Service Bulletin No: 27-026

Modification No: EC-18-0242

**FLIGHT CONTROLS - FLAP DRIVE SYSTEM - INSPECTION OF THE INBOARD FLAP FAIRINGS AFT AND THE FRONT INBOARD TENSION RODS****1. Planning Information****A. Effectivity**

PC-12/47E aircraft MSN 1819 thru 1843 and 1845 thru 1854 only.

Incorrect Contours - Inboard Flap Fairing Aft  
Figure 3

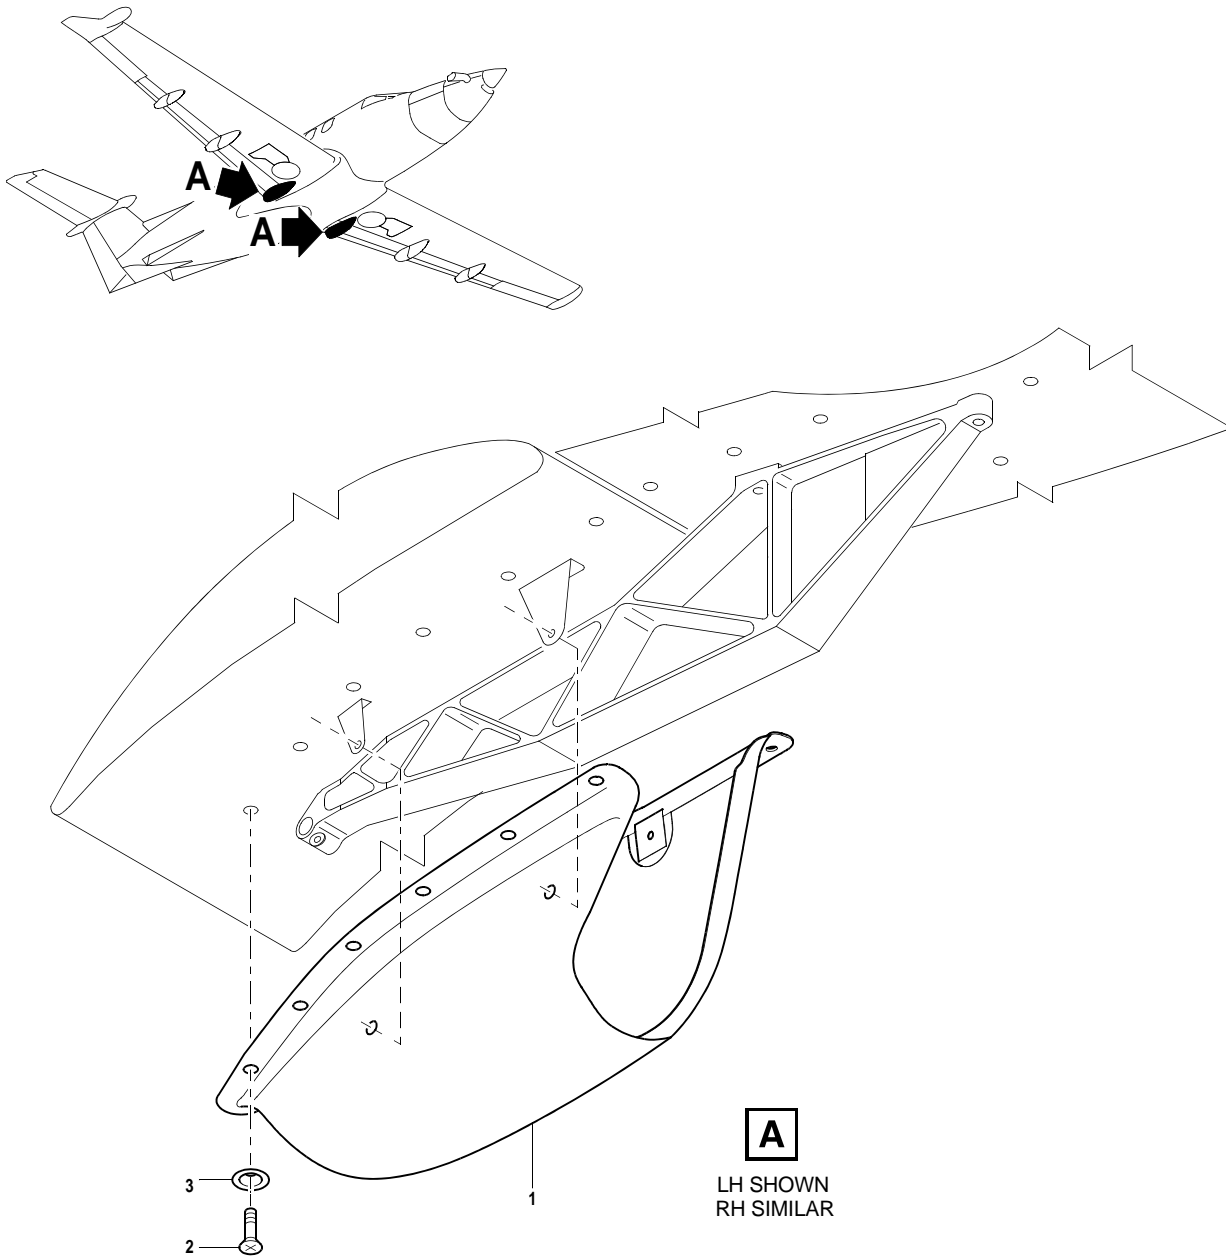
- (1) Do an inspection of the left and right IFFA to determine if the contour is the correct shape:
  - Figure 2 shows the correct (non symmetrical) contours of the left and right IFFA
  - Figure 3 shows the incorrect (symmetrical) contours of the left and right IFFA.
- (2) If the left and right IFFAs each have the correct contours as shown in Figure 2, do step 3.D.Close Up.
- (3) If the left or the right IFFA has incorrect contours as shown in Figure 3, do step 3.C.Modification.

Refer to Figure 3.

**NOTE:** It is only necessary to examine the tension rod if the related IFFA [1] has been modified.

- (a) Examine the tension rod of the related left and/or right IFFA [1] for chafe damage.
  - (b) If chafe damage is found, replace the tension rod, refer to AMM 12-B-27-51-01-00A-920A-A.
- (13) Install the IFFA [1] with the screws [2] and washers [3].

Inboard Flap Fairing Aft - Removal/Installation  
Figure 1

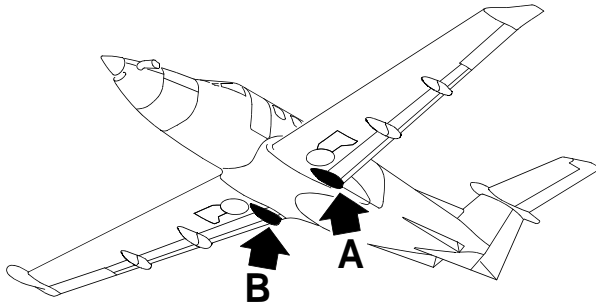
Refer to Figure 1.

- (1) Hold the IFFA [1] and remove the screws [2] and washers [3] that attach it. Remove the IFFA [1].

- (5) Remove the template.
- (6) Carefully cut and remove the material from the IFFA [1].
- (7) Temporarily install the IFFA [1] with four screws [2] and washers [3] at the edges to hold it in position on the flap.
- (8) Measure the clearance between the tension rod and the IFFA [1]. Make sure that there is a minimum of 5 mm (0.2 in) clearance.
- (9) Hold the IFFA [1] and remove the four screws [2] and washers [3] that attach it. Remove the IFFA [1].
- (10) If the clearance between the tension rod and the IFFA [1] is less than 5 mm (0.2 in), rework the IFFA [1] as necessary.
- (11) Apply the necessary surface finish.
- (12) Examine the tension rods:

Correct Contours - Inboard Flap Fairing Aft  
Figure 2

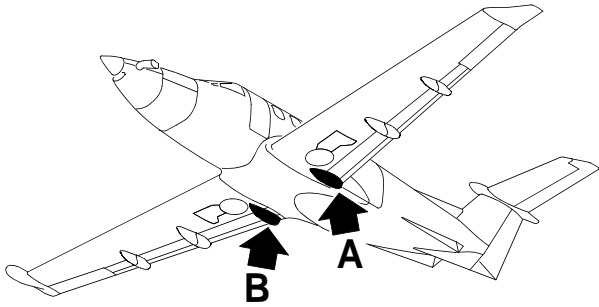
Refer to Figure 2 and Figure 3.

APPENDIX A  
A4 TEMPLATE - LEFT IFFA

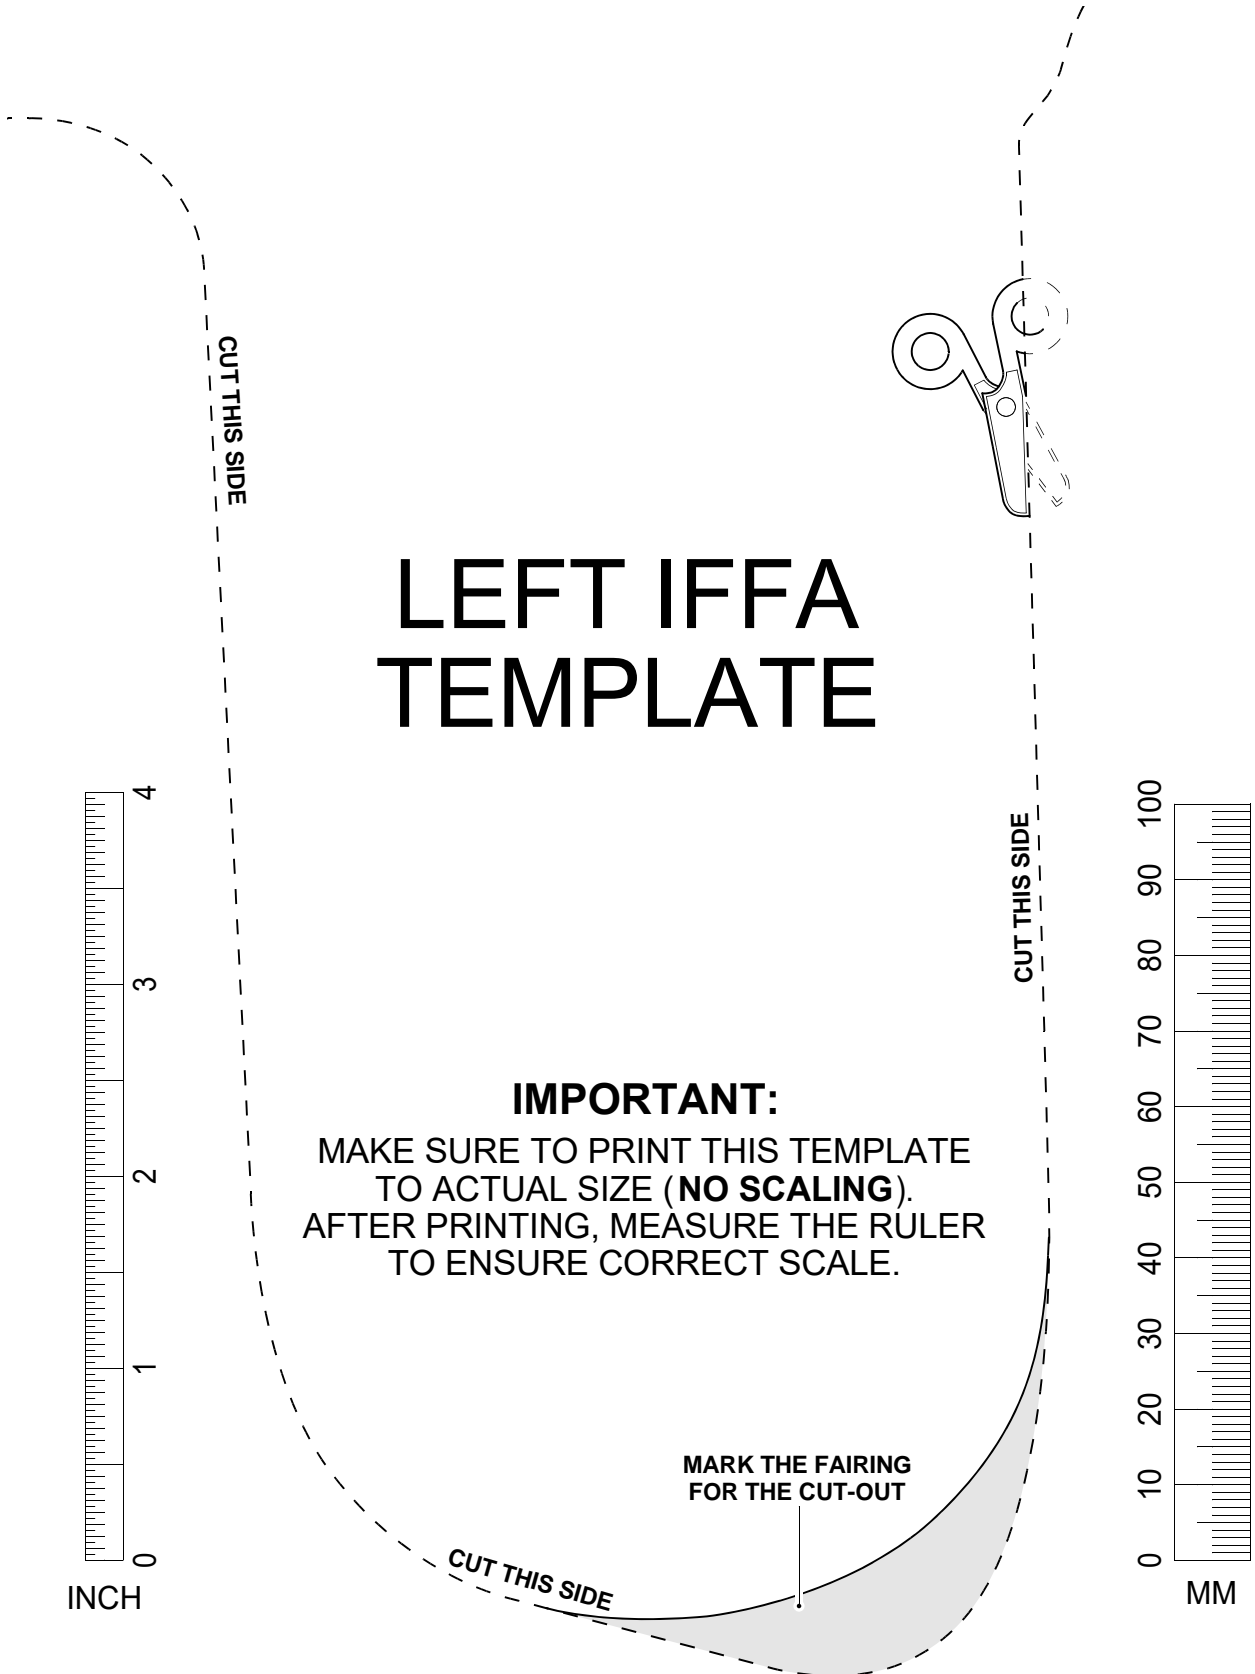
MARK THE FAIRING  
FOR THE CUT-OUT

- (2) Print the template to **Actual Size**:
  - For A4 paper size, print the left and right IFFA templates in Appendix A
  - For US Letter paper size, print the left and right IFFA templates in Appendix B.

- (4) Make marks on the IFFA [1] for the cut-out, as shown on the template.

APPENDIX B  
US LETTER TEMPLATE - RIGHT IFFA

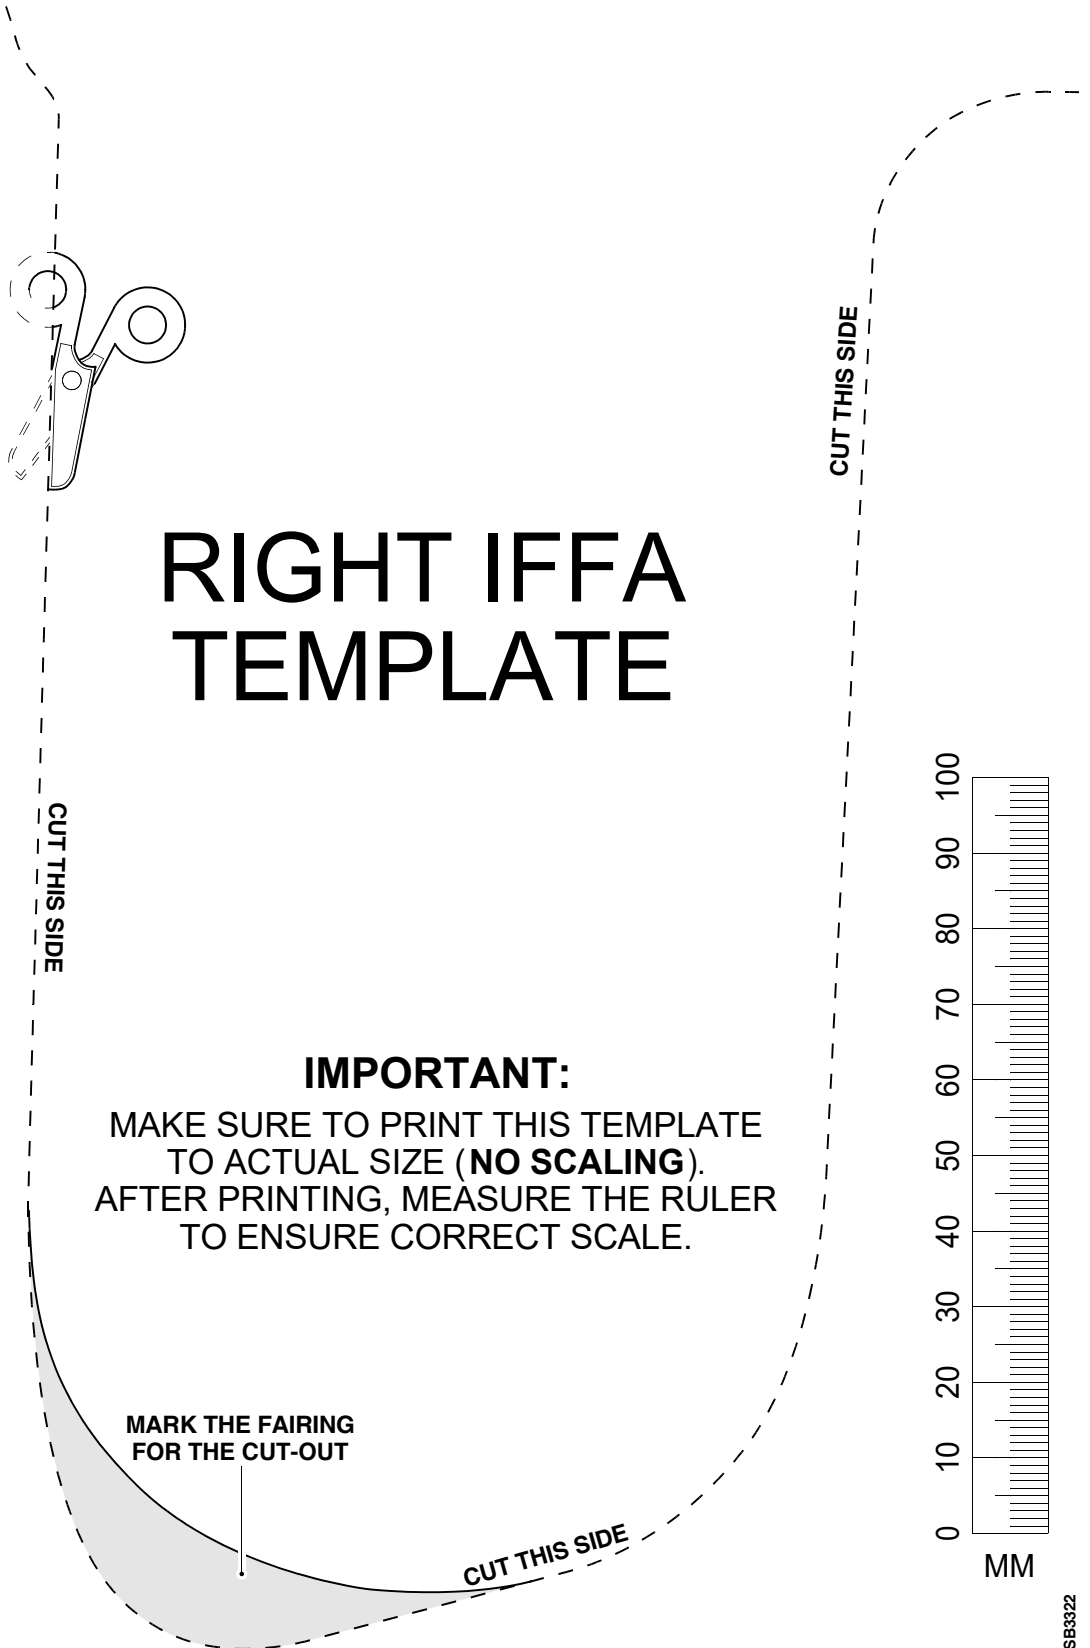
MARK THE FAIRING  
FOR THE CUT-OUT
